OEHI Response to CEC Data Request A60

Amended Application for Certification
for
HYDROGEN ENERGY CALIFORNIA
(08-AFC-8A)
Kern County, California

Technical Area: Biological Resources
Author: Amy Golden

CARBON DIOXIDE PIPELINE ROUTE AND OEHI PROJECT

FIGURE 1

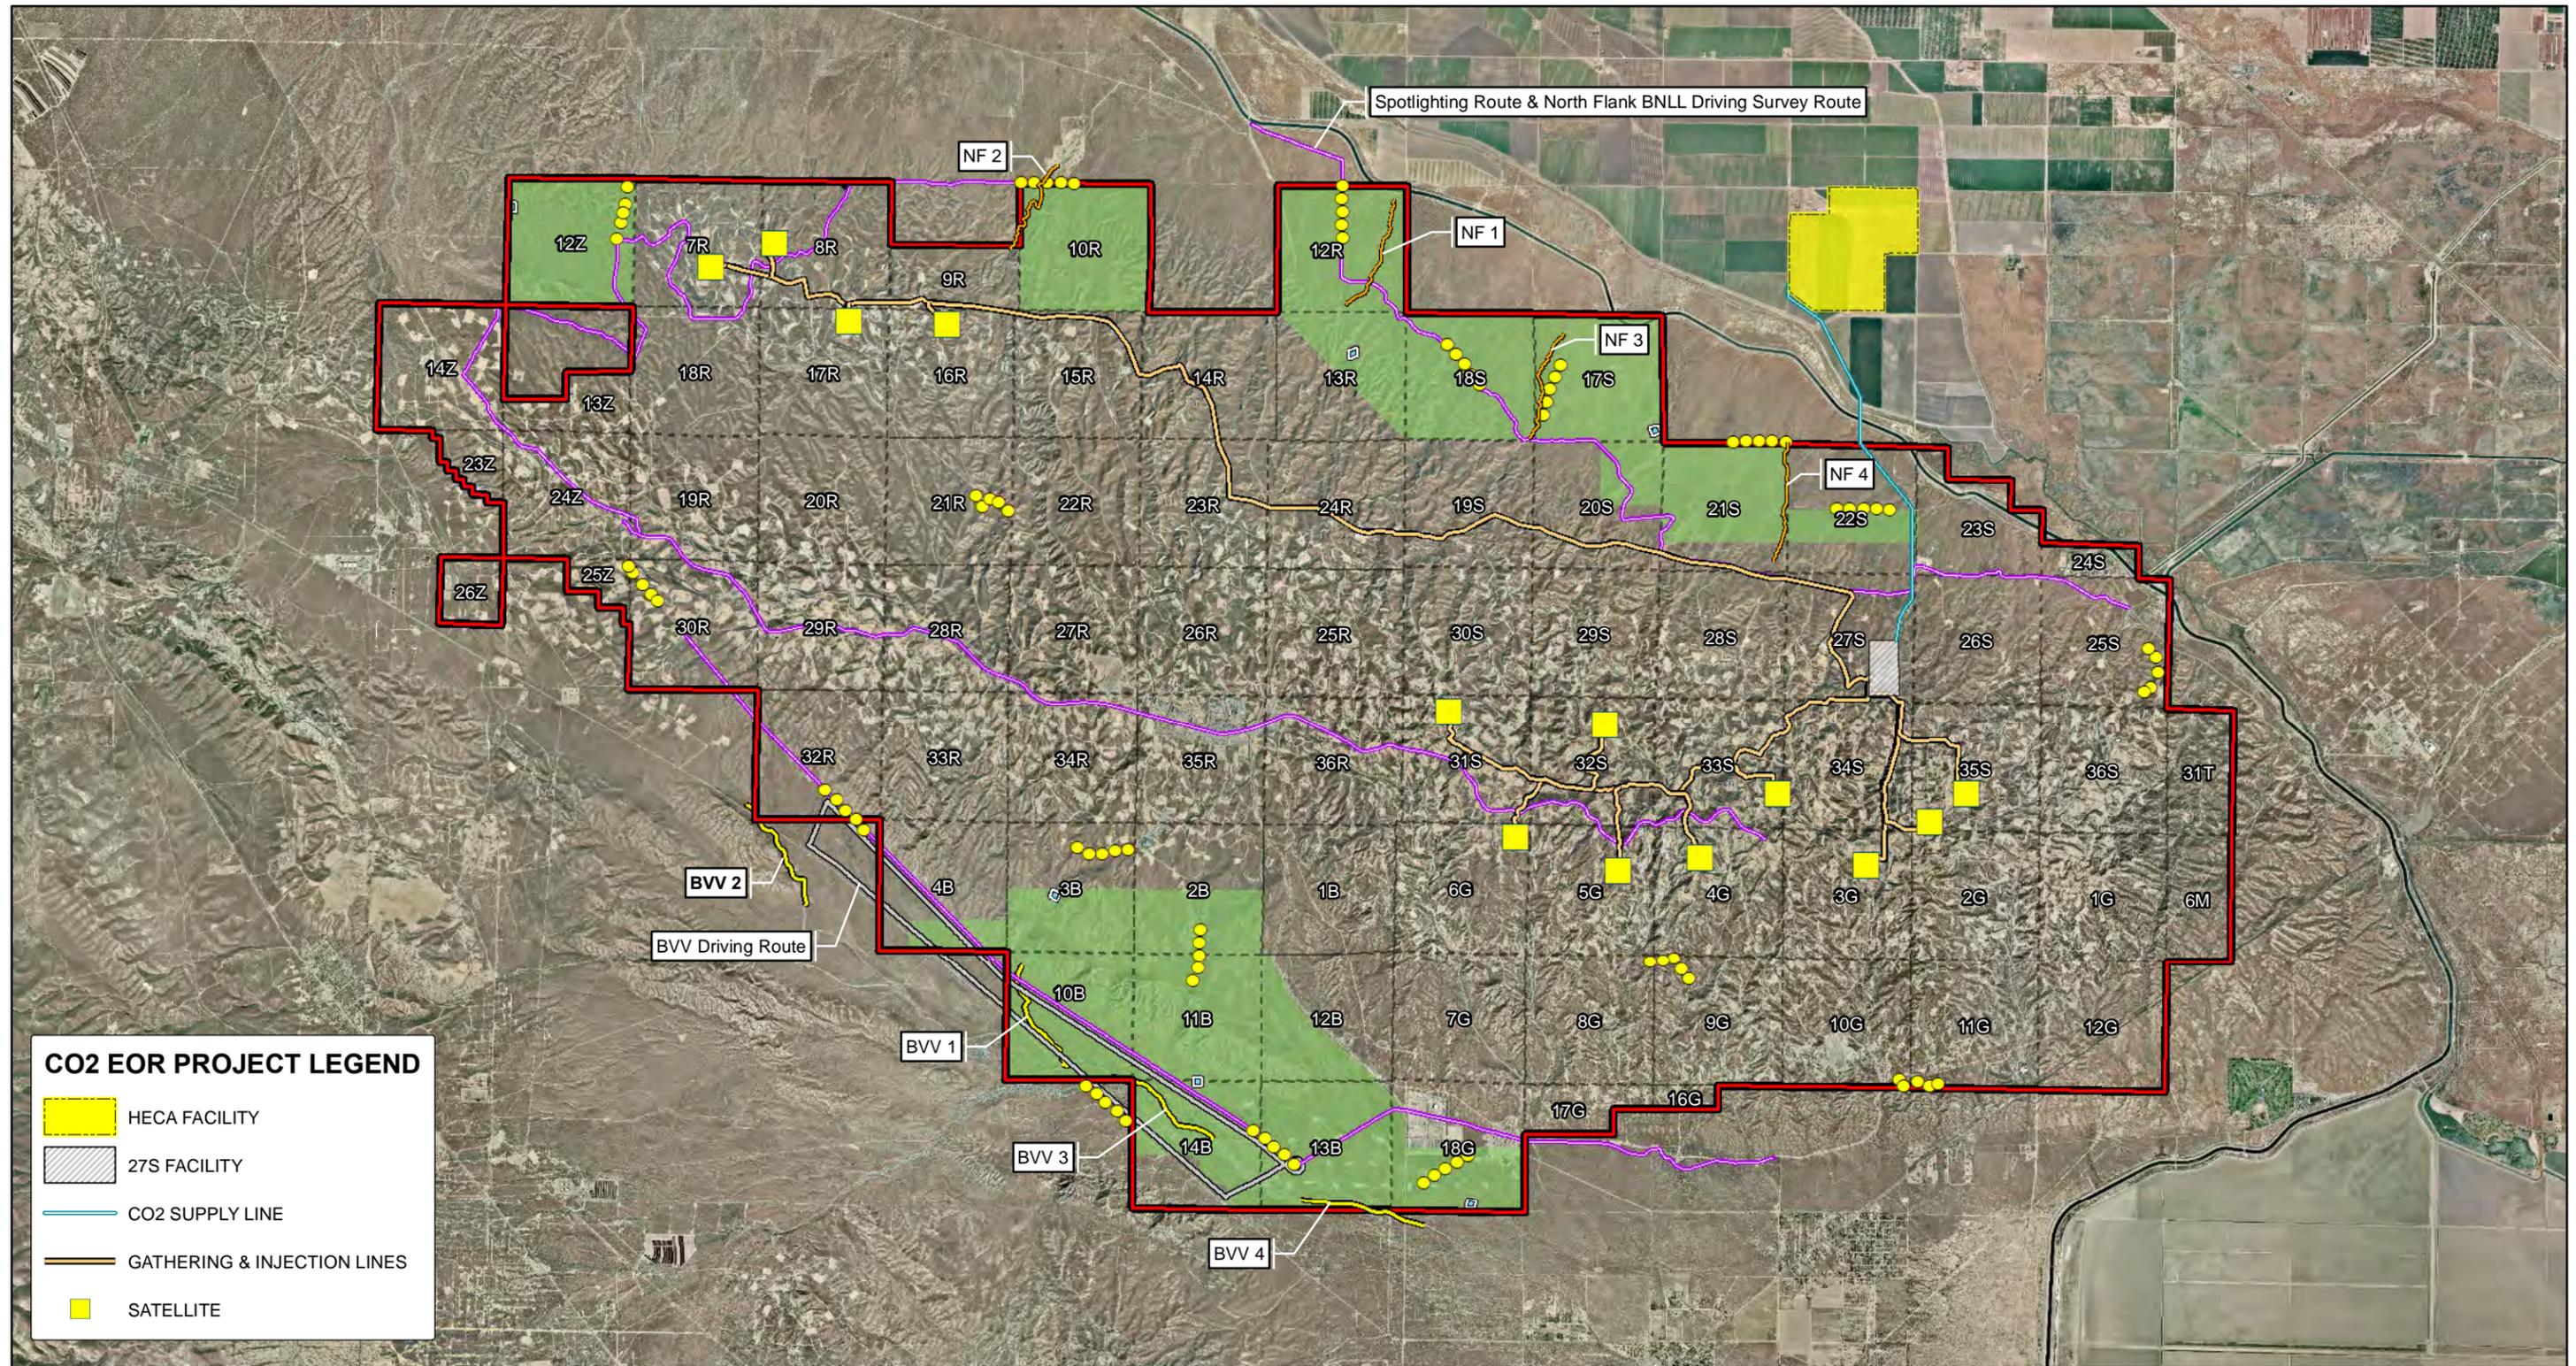
- A60. Please provide an aerial exhibit(s) at an appropriate scale (e.g. 1 inch: 7,000 feet) showing plant and wildlife species GPS data collected during previous monitoring years. On the exhibit, please also show a conceptual drawing overlay (such as AutoCAD) of the 13 satellites shown in Appendix A.

The attached Figures 1-7 show the conceptual overlay of the OEHI CO2 EOR Project. Figures 1-6 show wildlife species monitoring data collected during previous monitoring years 2007-2011, and Figure 7 shows floristic survey results 1995-2001.
